Kennedy Associates Architects (KAA)

1-7 Fergerson Avenue,
Fairfield NSW - Seniors
Housing Development

Access Review – rev 1.1

29 August 2023

Figure 2. Proposed typical SEPP toilet

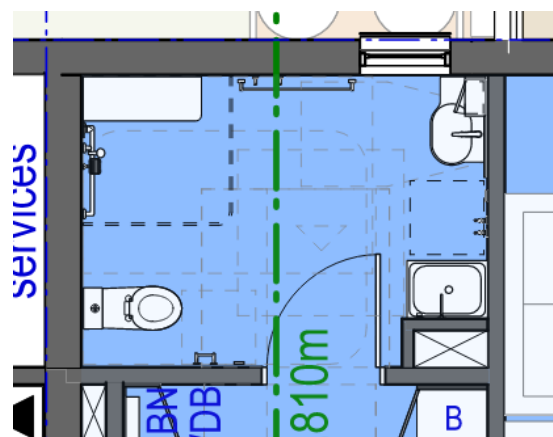
All main bathrooms located on ground floor suitably sized are compliant with AS1428.1. Fig.1.1. However, bathrooms that do not meet AS4299 Clause 1.4.12, Fig.1.1. (visitable). This requirement will be supported by MGAC given they comply with AS1428.1 and offer a more significant room to manoeuvre. Furthermore, the visitable toilet function could also be performed by a compliant AS1428.1 bathroom.

Figure 2. Non-Compliant Pedestrian Kerb Ramps Locations and Upgrade works Proposal.

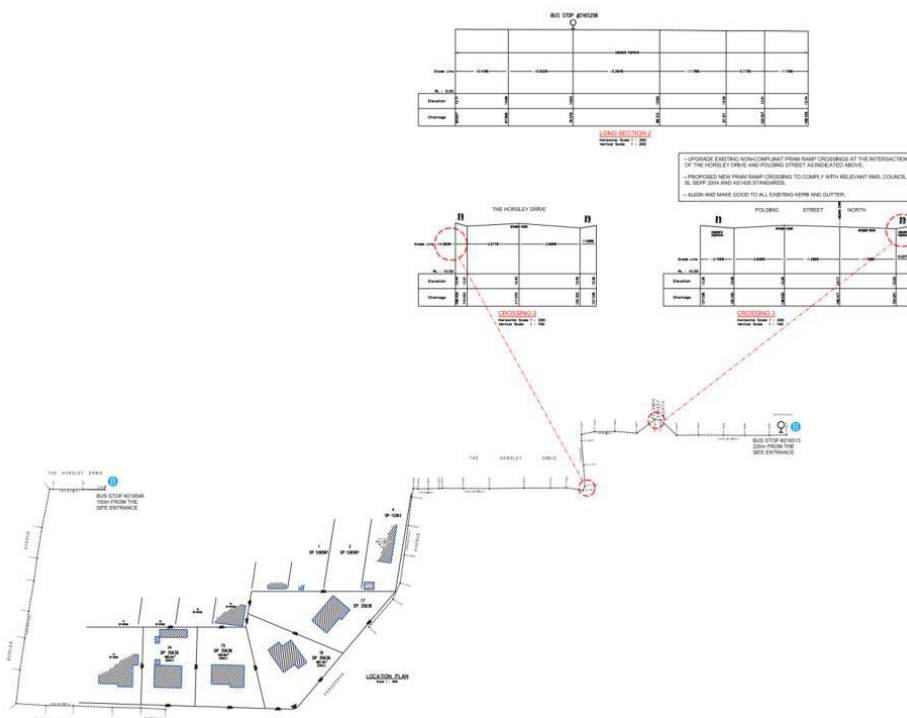
The development is located within 400 meters approximately of two bus stops on The Horsley Drive, which complies with the above clause (i). However, there are two non-compliant kerb ramps being identified on the path of travel from the site to the bus stops and from the bus stop to the site, these are shown above in Figure 3 and 4.

Kerbs ramps non-compliances are to be addressed in accordance with the local council requirements shown below in Figure 7.

It is recommended that top landings are provide in accordance with AS1428.1 shown below in Figure 6.

Figure 8. AS1428.1 Upper landing diagram.

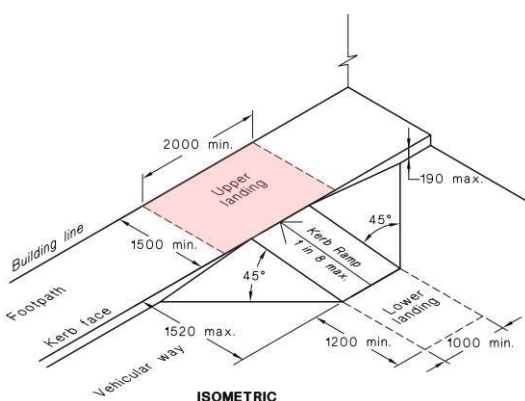
Note: Upper landings 1500mm x 1500mm minimum clear circulation to be provided where practicable due to the constrains of the existing conditions.
